## DEFENSE NUCLEAR FACILITIES SAFETY BOARD

**MEMORANDUM FOR:** G. W. Cunningham, Technical Director

**SUBJECT:** Molten Salt Reactor Experiment: Potential Safety Issues

Figure 2: The Molten Salt Reactor Experiment Auxiliary Charcoal Bed

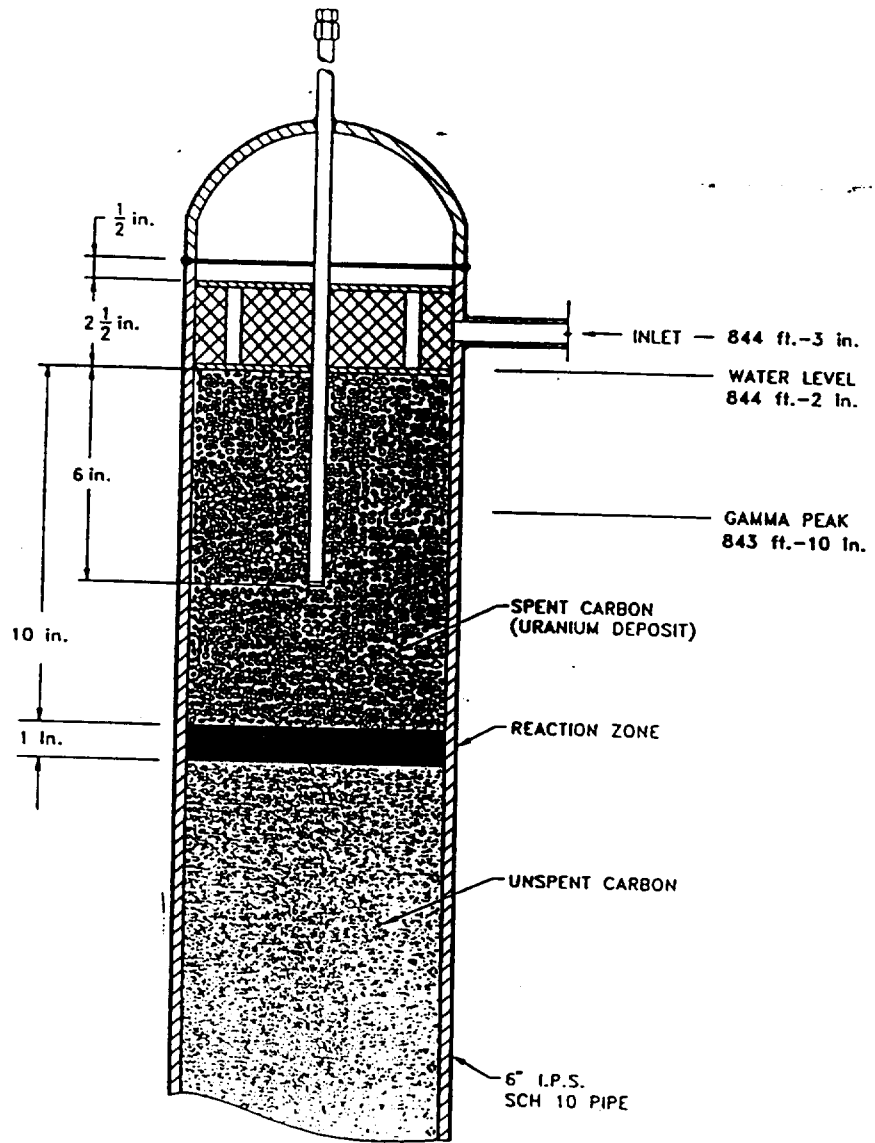
The ACB, part of the off-gas treatment system, consists of two U-tube charcoal traps which are fabricated from six-inch diameter stainless steel pipe. They are approximately 20 ft long per leg. The ACB is located in a 10 ft diameter, 24 ft deep underground concrete pit. The ACB pit was filled with water to cool the charcoal traps and provide shielding during reactor operation. The ACB pit remained full of water until recently. Therefore, the charcoal traps were fully submerged when the uranium was discovered to be located in the ACB.

For the ACB,  $UF_4$  and  $UF_6$  are mixed with the charcoal. The charcoal acts to reduce the uranium atom density. ORNL examined the potential for a criticality for both water inside the ACB and water outside the ACB. ORNL criticality calculations indicate that the only credible criticality scenario for the 2.6 kg of  $^{233}U$  is when water enters the ACB and fills the void spaces in the charcoal bed. ORNL calculations also indicate that water reflection alone, i.e., water completely surrounding the outside of the ACB, is insufficient to cause a criticality event. Thus, the current mass of uranium is theoretically sufficient for a criticality, but sufficient moderation is not present. The recent draining of the ACB pit has significantly reduced the amount of reflection.

the Fuel Drain Tanks. This includes the consideration of natural water sources, such as groundwater in close proximity to the drain tank cell and the ACB pit. The controls in place to isolate each of these water sources from the three suspected locations of uranium need to be assessed, documented, and positively controlled. From review of existing documentation and discussions with ORNL personnel, it is not apparent that such an action will be completed promptly. A MSRE Remediation Project Summary Schedule presented to the Board staff on January 4, 1995, noted that the partition of the off-gas system and the elimination of water sources would not be completed until the end of the calendar year.
